**ATTABAD LAKE
HYDROPOWER PROJECT
(54 MW)**

**FEASIBILITY REVIEW /
VALIDATION REPORT
(FINAL)**

DOCUMENT NO.: 4464-FRR

MAY 2023

Figure 5.1: Simplified Geomorphological Map of Project Area

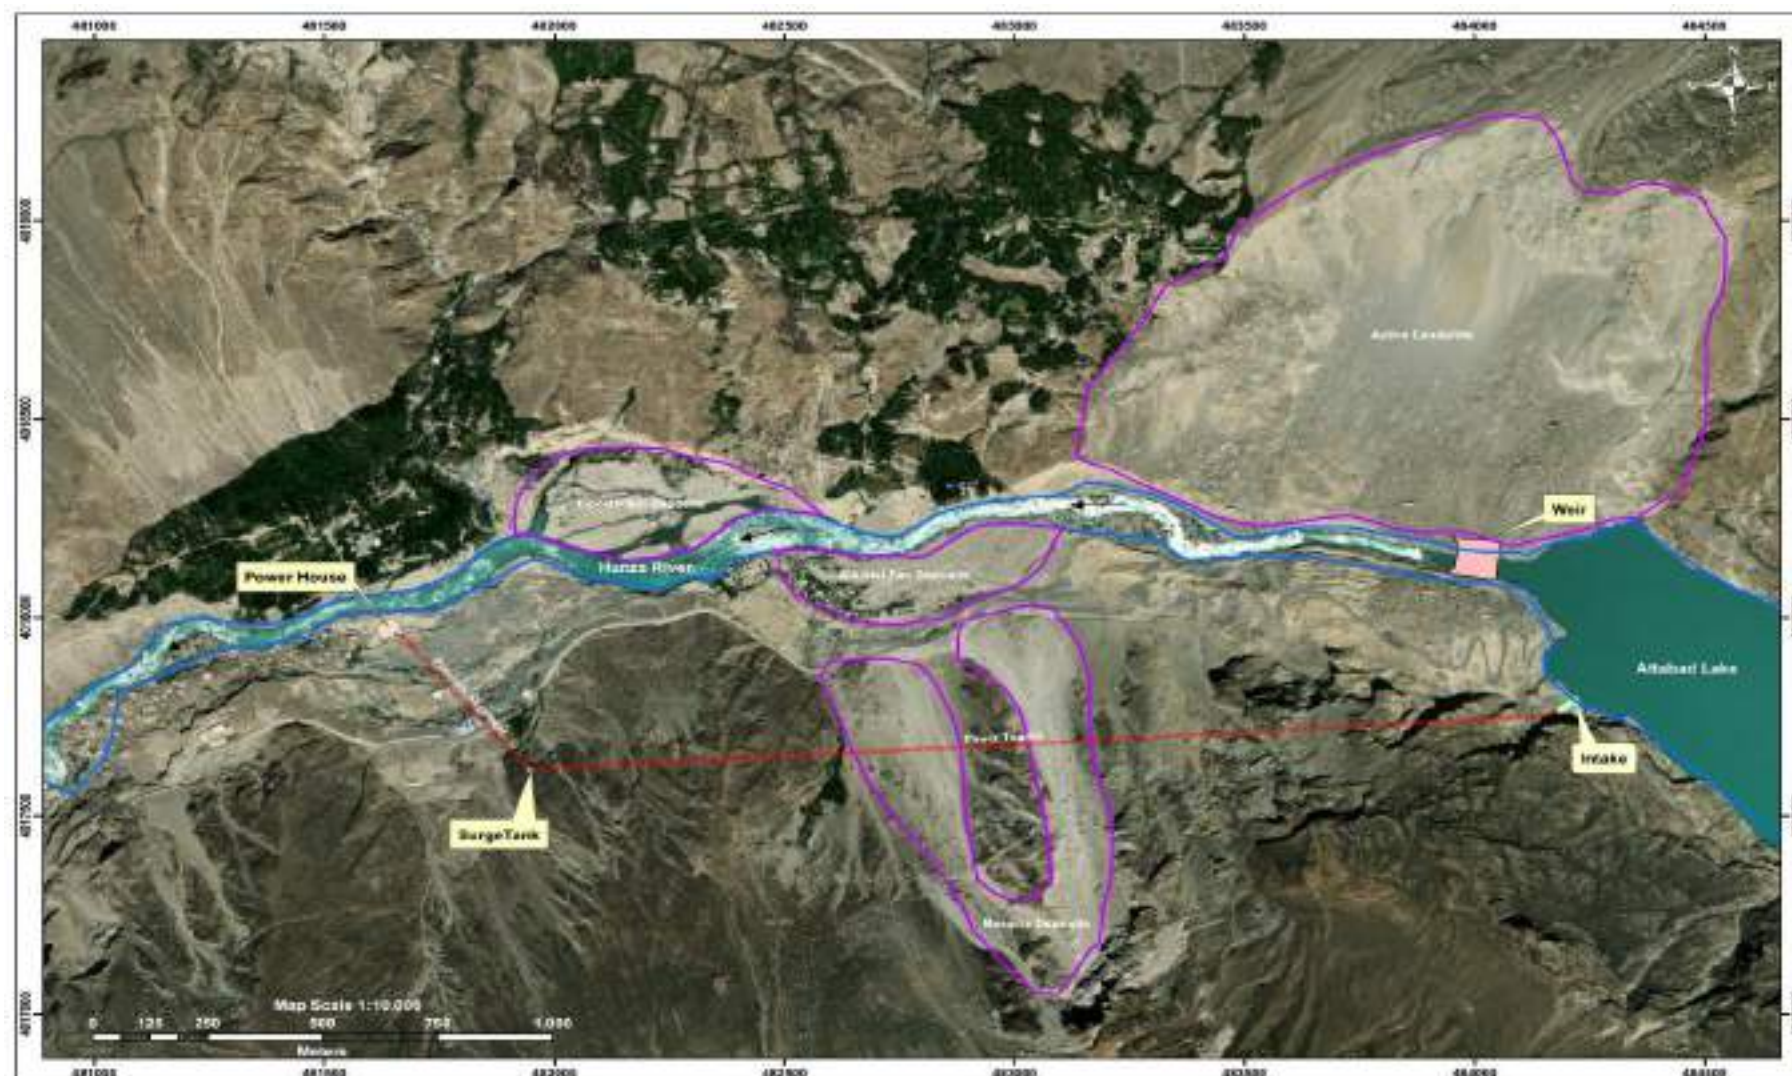
The reviewer has made the geomorphologic assessment of the project area and its closed vicinity using satellite images and remote sensing techniques as shown in Figure 1. The segment of Hunza valley wherein the various components of the project are situated reflects very high relief conditions marked by relatively steeply inclined extensive mountain slopes along right side of the valley as compared to the left bank mountain slopes.

In perspective of the aforementioned volatile slope conditions, it is recommended that during detail design, prior to the initiation of specific and specialized investigations, a comprehensive and overall baseline terrain characterization based on geologic, geotectonic, geomorphologic, seismic geohazard and prevailing climatic conditions should have been conducted. Simplified Geomorphological Map of project area is shown in Figure 5.1.

Figure 5.4: Proposed Borehole Locations of the Weir and Intake Area

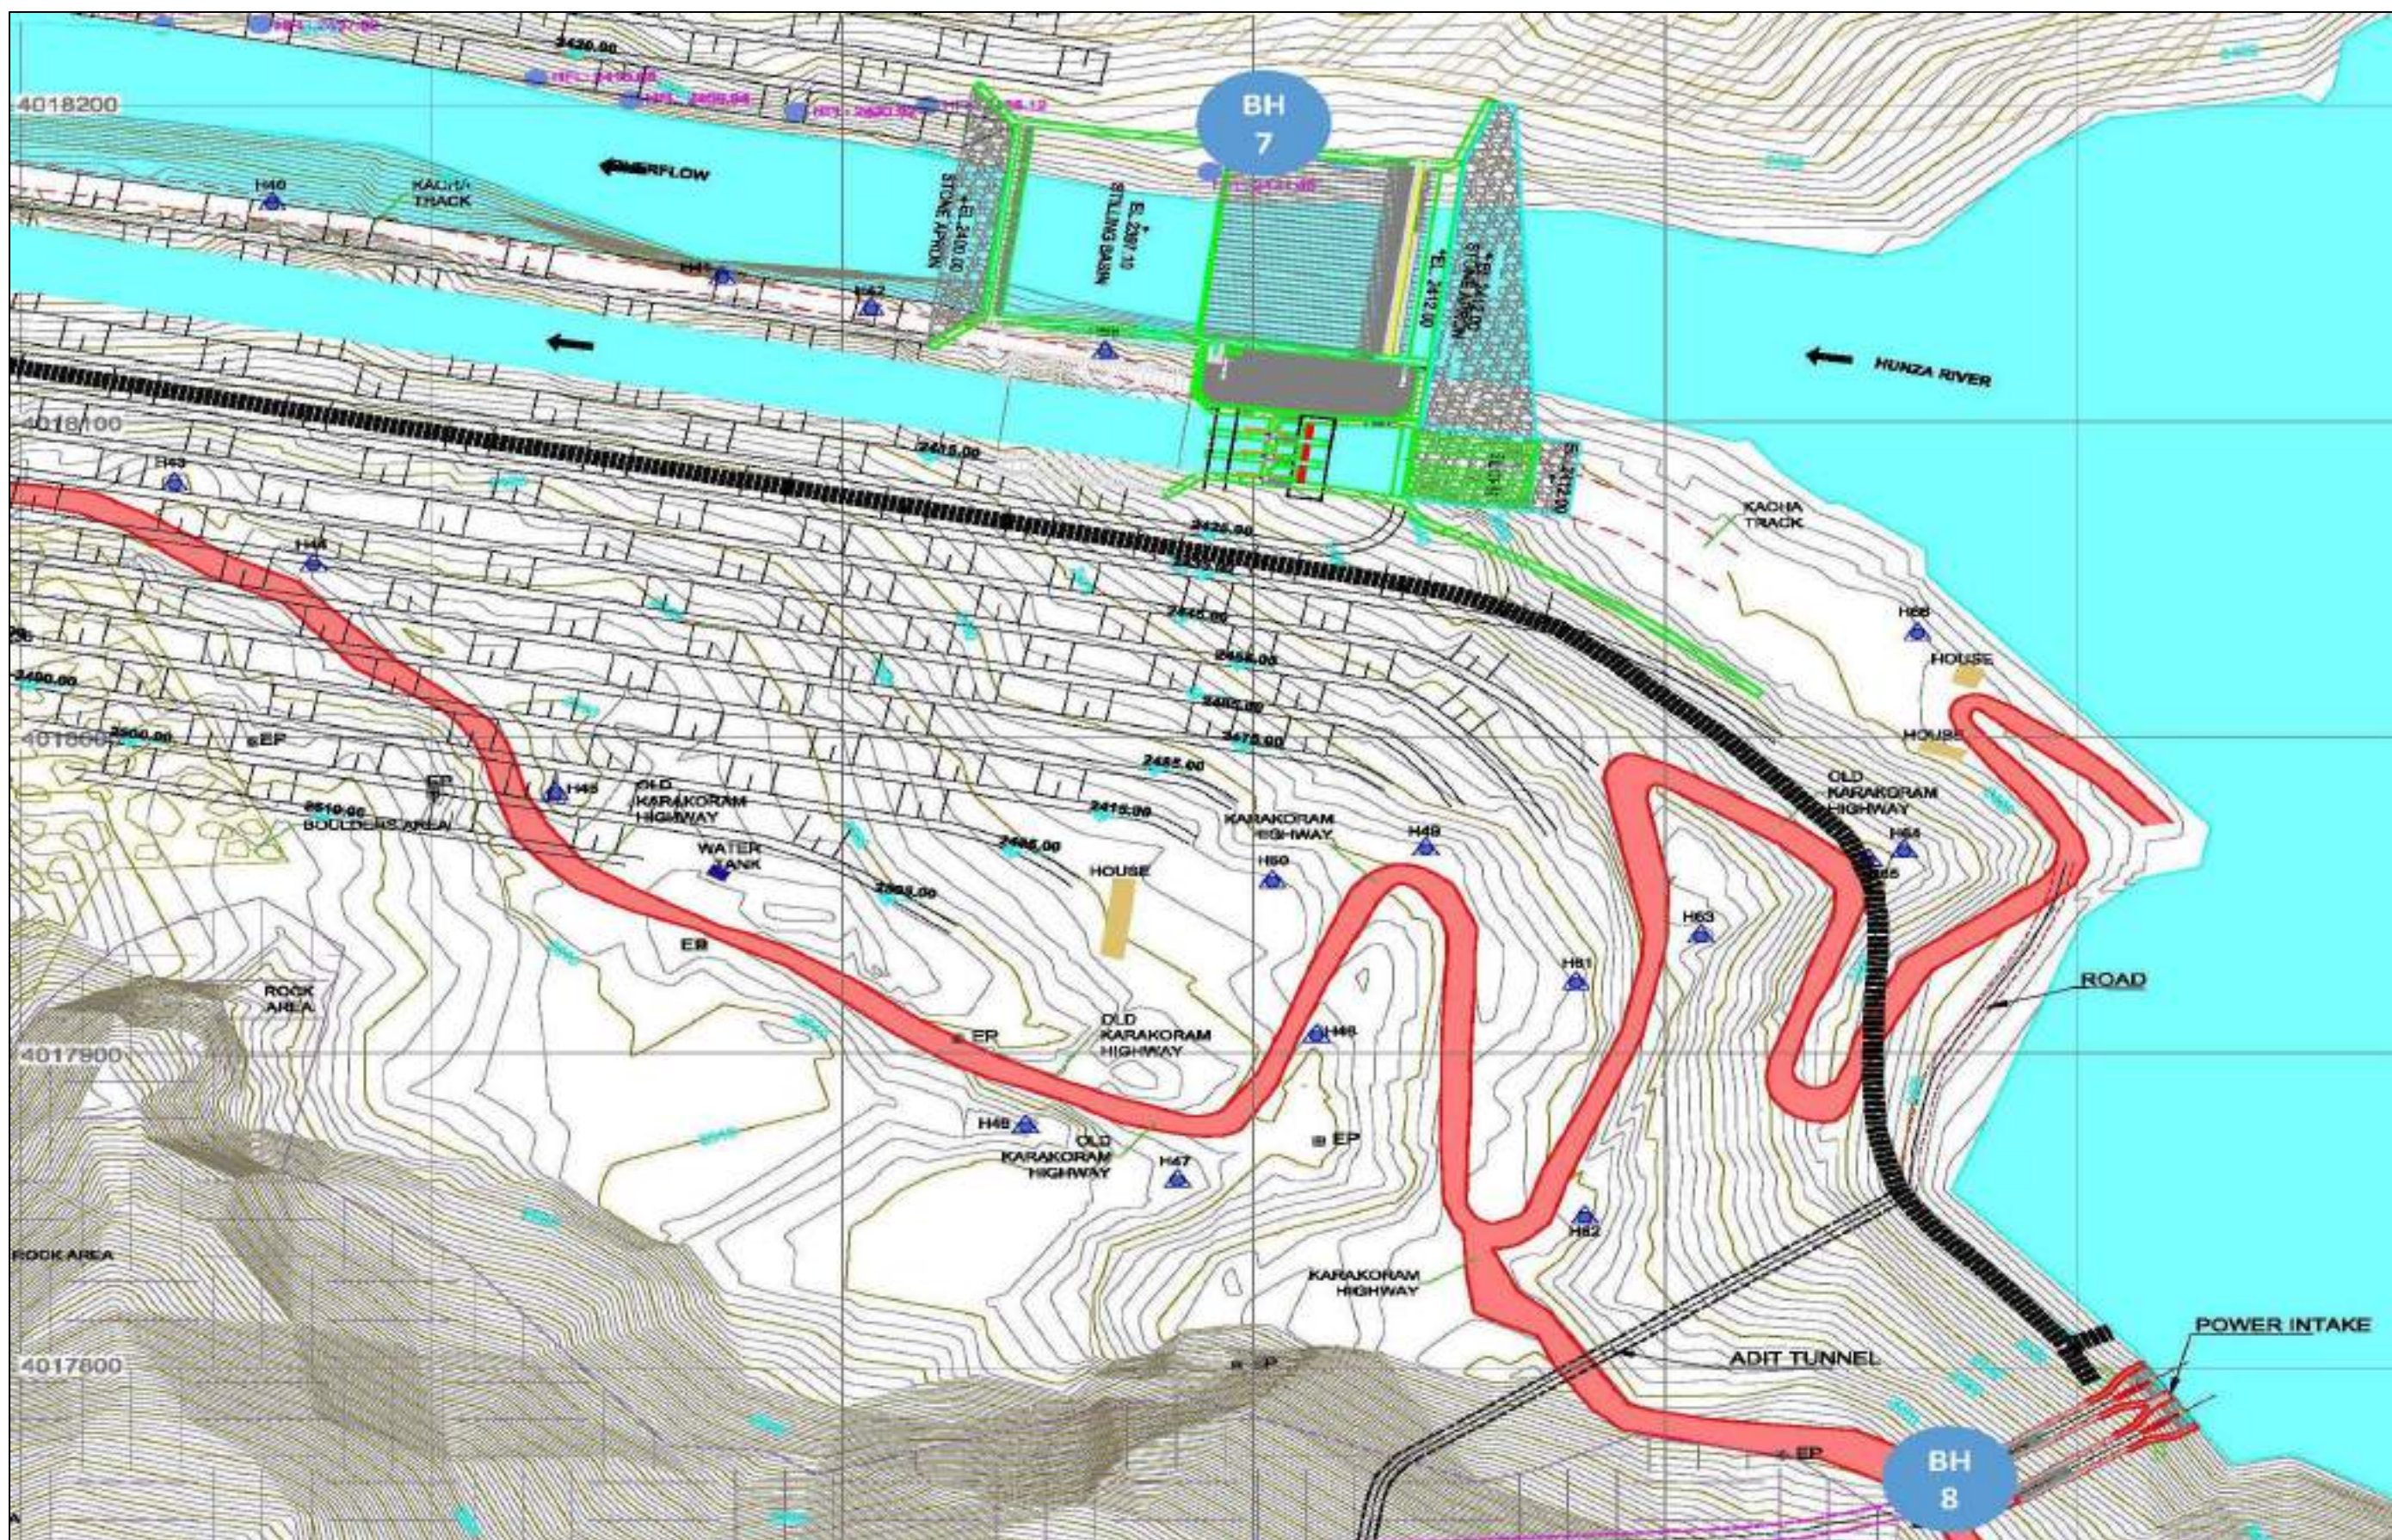
In order to complete the set of data obtained from the ground surveys drilling of some additional boreholes to evaluate the geotechnical and geological conditions at the project components are recommended for Detail design studies by EPC Contractor. These boreholes should be located on the right bank of the weir where no previous borehole present, water intake, surge tank and penstock alignment, in the present powerhouse location (can be used for tailrace structure) and new proposed location of powerhouse.

The locations of the proposed boreholes is given in Table 5.9 and shown in Figure 5.4 and Figure 5.5. This proposal is subject to finalization of project layout during detail design studies.

Figure 5.5: Borehole Locations between Surge Tank and Powerhouse

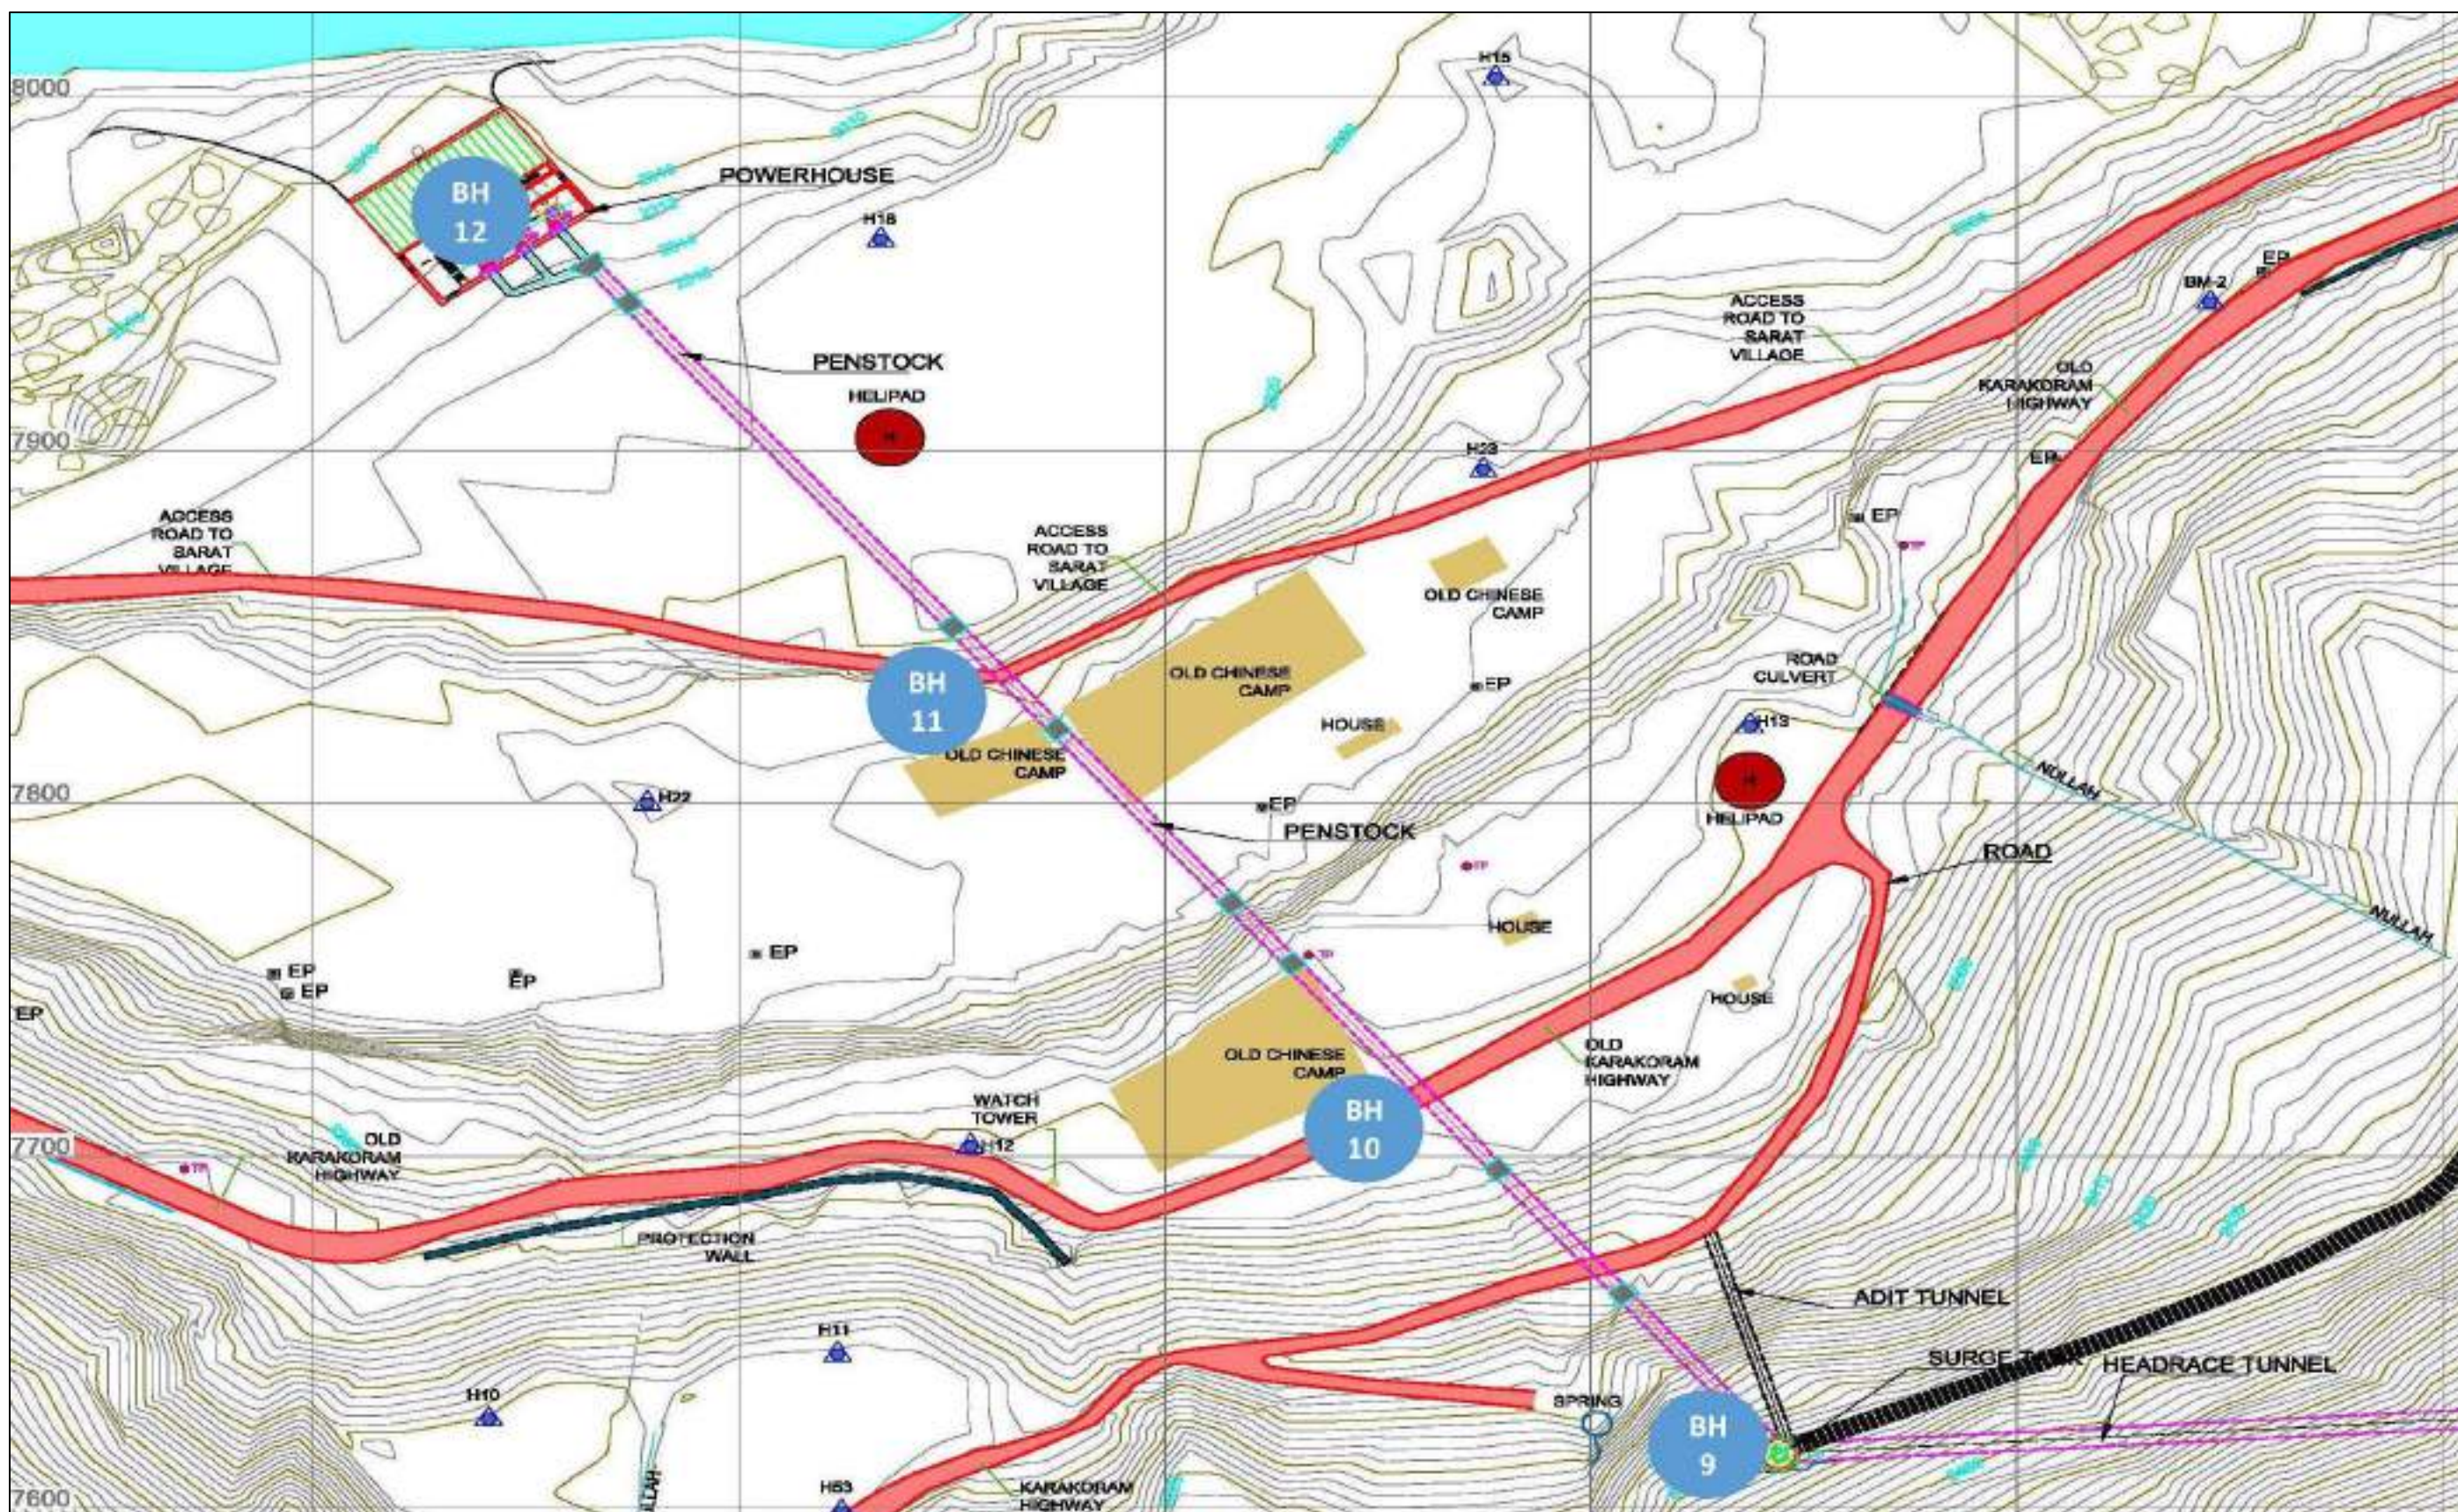
Menard pressuremeter test is proposed in the location of the penstock and powerhouse.
